METROPOLITAN GOVERNMENT OF NASHVILLE AND DAVIDSON COUNTY

STAFF RECOMMENDATION
712 Benson Street
November 19, 2018

Application: New Construction—Addition (Violation, Revision to Previous Approval)

712 Benson Street, left.

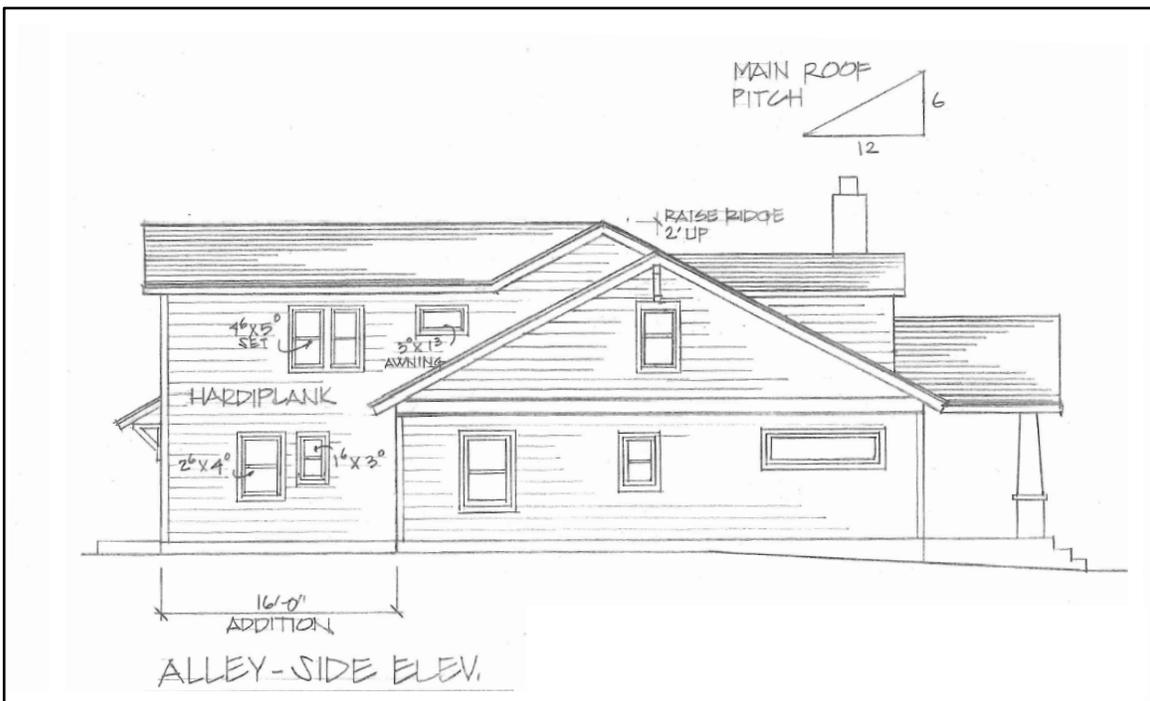
The addition has been constructed with the ridge height increasing by two feet, ten inches (2'-10"). The new two-story rear addition, therefore, is also ten inches (10") taller than it had been approved.

Staff finds the additional ten inches (10") of height on the new ridge to be inconsistent with previous decisions of the Historic Zoning Commission, and to not meet section II.B.1.a and II.B.1.b of the design guidelines. Staff recommends that the ridge height be reduced to two feet (2') above the original ridge as was approved.

Recommendation: Staff recommends that the ridge-raise and rear addition be lowered to two feet (2') above the height of the historic house as was approved.
